**Safety and Reliability of the Muskrat Falls Dam, in
Light of the *Engineering Report* of 21 December 2015
by Nalcor/SNC-Lavalin**

Submitted to the
NL Public Utilities Board's

*Investigation and Hearing into Supply Issues and
Power Outages on the Island Interconnected System*

13 October 2016

Figure 2.1. Deviator stress-strain (deformation) relationships of different kinds

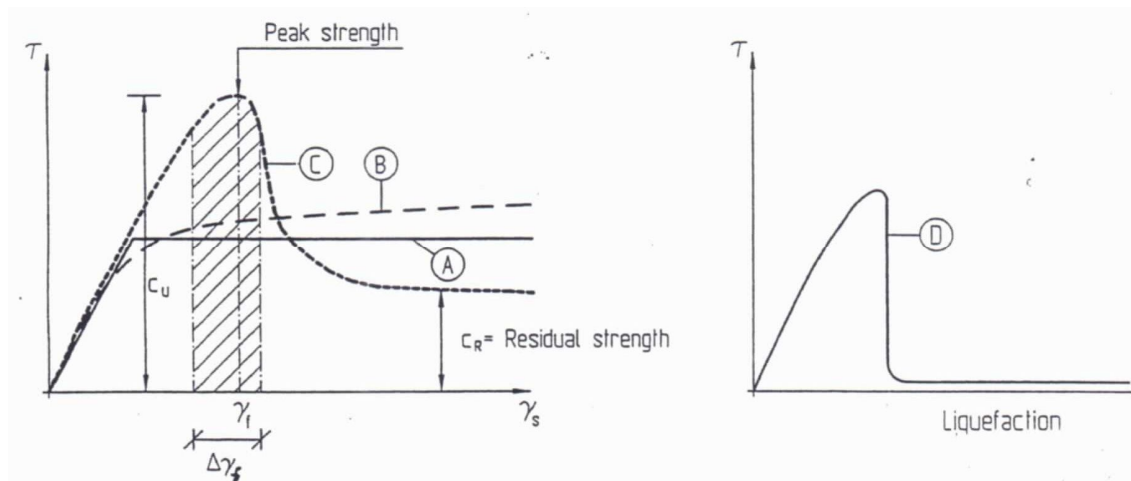
Hence, in materials with properties like those in cases (A) and (B) in Figure 2.1, progressive failure is simply not possible, whereas in cases (C) and (D) progressive failure may be a likely event.

Do the stress-strain curves of the soils in the North Spur correspond to curves A and B in Figure 2.1, or is it possible that deformations due to additional loading may result in stress-strain (deformation) relationships such as those of curves C or D?

Figure 4.1. Stress-strain (deformation) curves for consolidated, undrained vane tests at different strain rates [9]. Legend: brott = failure, Vridning = torsion, dygn = day, vecka = week, grader = degrees.

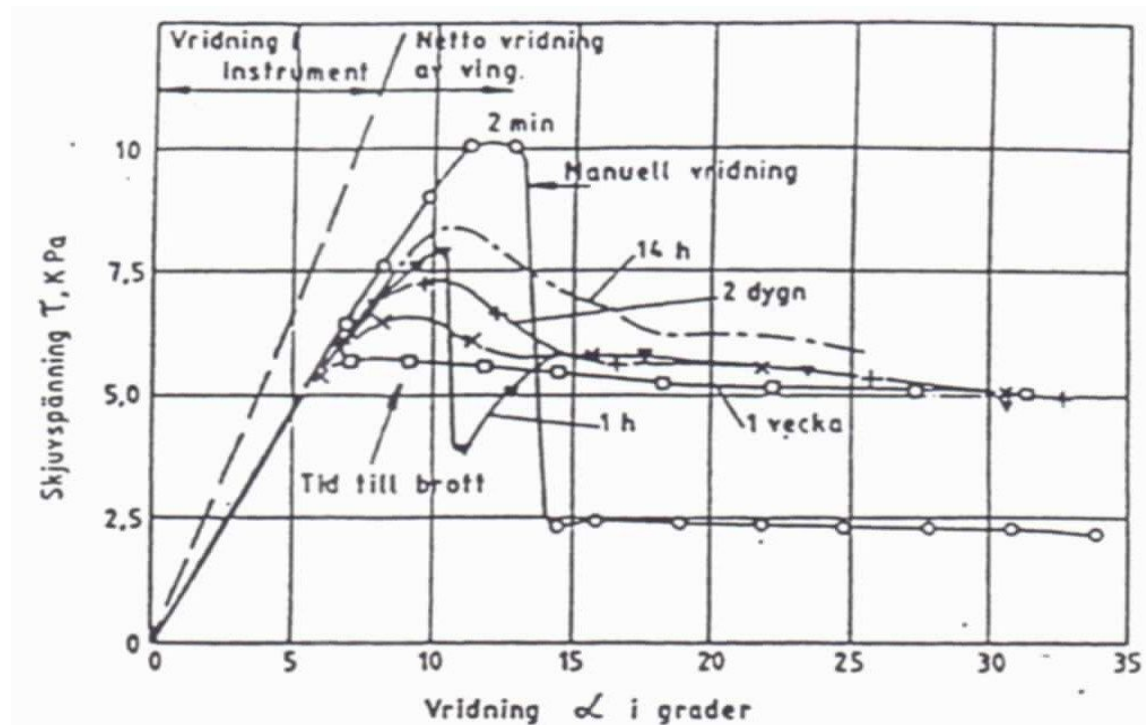
In this regard the Reviewer finds it anomalous that the **REPORT** does not contain diagrams of the stress-strain (deformation) relations for soil samples that are typical of identifiable critical layers in the Stratified Drift.

This Reviewer believes that, even now, Nalcor/SNC-Lavalin must present such diagrams. These are not likely to correspond to the “elastic-plastic” relations that they have generally applied.

Figure 5.1. Potential failure planes (I and II) possibly leading to progressive failure development.

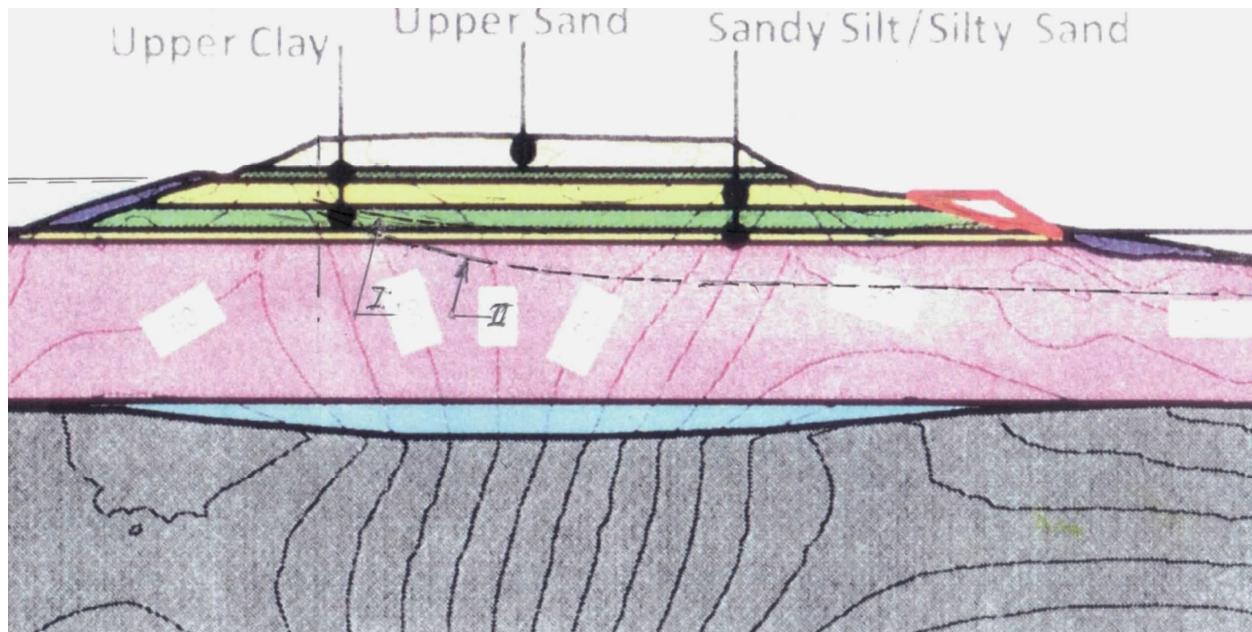
In soil mechanics there exists no rule stating that developing failure surfaces are even likely to be horizontal. This is true irrespective of whether the ground surface above is sloping or not.

A forward-acting failure development near the cut-off wall (COW) may, for instance, initially progress along the sedimentary orientation in the Stratified Drift, but may just as well develop

more steeply through the Upper Clay and then progress further into sensitive layers in the Lower Clay formation. See, for example, the potential failure planes I and II in **Figure 5.1**.

Conclusion. The **REPORT** presents no valid justification for presuming only horizontal failure planes through soil layers in the North Spur. The rough analysis made above does not claim to render a precise account of the risk of forward (downhill) progressive failure, but it does demonstrate the need to perform a thorough study of failure planes other than horizontal ones.

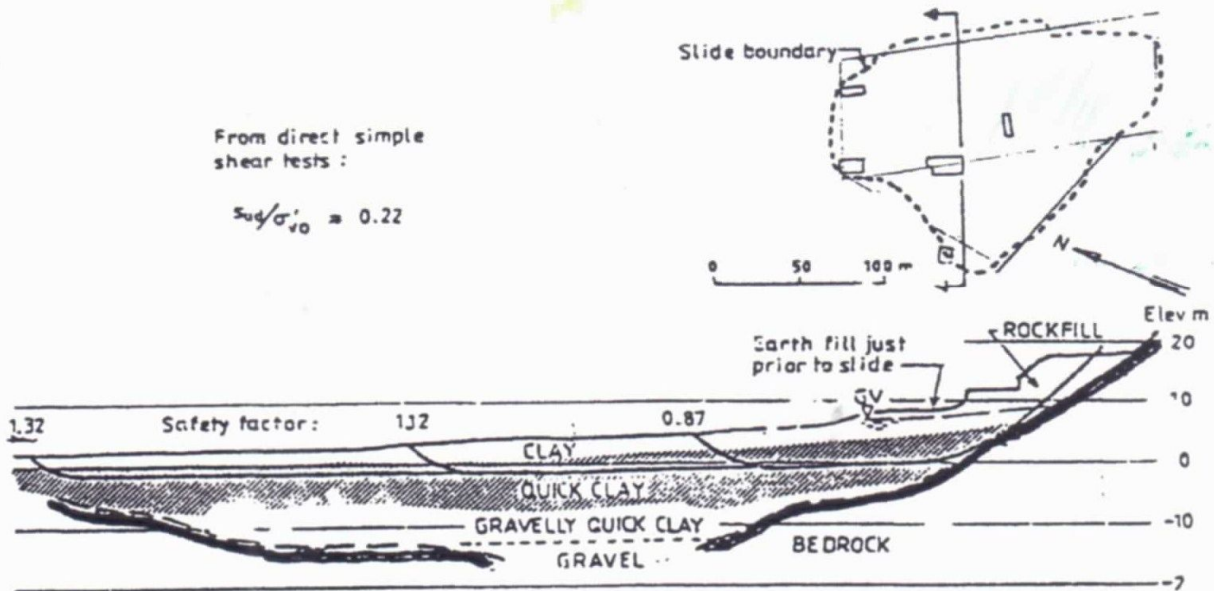
Investigations by the Reviewer have shown that, when slip circles in sensitive soils extend more than 50–70 metres, safety factors based on LEM analysis may become seriously unreliable.

Further examples given in Ref. [15] show clearly that, depending on various parameters (such as geometry, time, stress-strain relationships, etc.), safety factors based on progressive failure analysis may be as low as 25% of the corresponding safety factors calculated using LEM analysis.

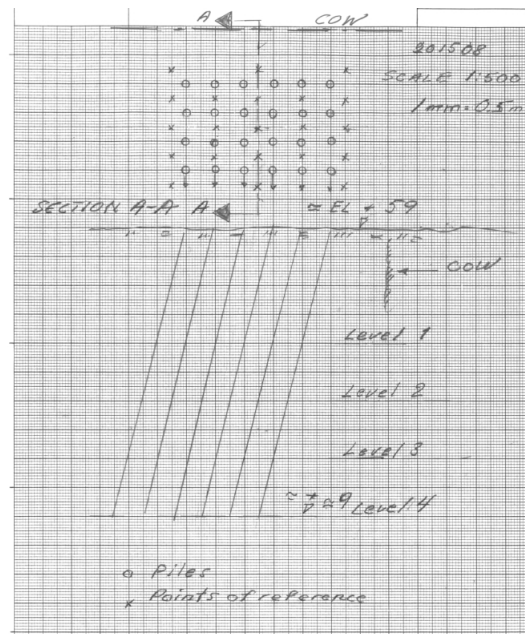
- 1) Within an area of say 20 metres x 30 metres, 24 piles are driven by a rammer in straight lines at 5-metre centres. A positive feature of such a test area is that it need not necessarily obstruct or interfere with ongoing construction work.

- 2) The piles may consist of 0.3 m diameter steel pipes fitted with splices every 10 metres. The pile tips should be flat and closed by a perforated steel plate to allow dissipation of water. Alternatively, other methods of drainage may be employed. A point of reference for each pile and its precise level must be fixed and registered.
- 3) All piles are driven 20 metres to elevation $\approx +39$, i.e. about 20 m below the ground surface level. The sequence in which the piles are driven is not crucial. The settlements of all reference points are then accurately measured, and excess pore water pressure is allowed to subside by drainage through the perforated bottom plates or by other means.

- 4) All piles are then driven another 10 metres to elevation $\approx +29$, i.e. about 30 m below the ground surface. The settlements of the reference points are measured and excess water pressure is again dissipated.
- 5) All piles are driven another 10 m to elevation $\approx +19$. The settlements of the fixed points are again recorded and excess water pressure dissipated. At this point the total soil settlement indicates roughly the amount of vibratory compaction of the loose Stratified Drift.
- 6) All piles are driven another 10 m to elevation $\approx +9$. The additional settlements generated in the Lower Clay are measured. Some degree of vibratory compaction may also be expected in this layer. Below, the recommended test pattern and depth levels are diagrammed together:

Impact tests of this kind are the best way to get a realistic notion of the true in-situ porosity of such soil layers. The above procedures yield a reliable indication of the effects on soil porosity of heavy vibratory impact. From the measurements of soil settlement it is possible to evaluate the inherent sensitivity of the soil profile, i.e. how sensitive the layers are to deviatoric deformation and to stress/strain reversals such as those caused by such large triggering loads as changes in water levels and seismic activity.
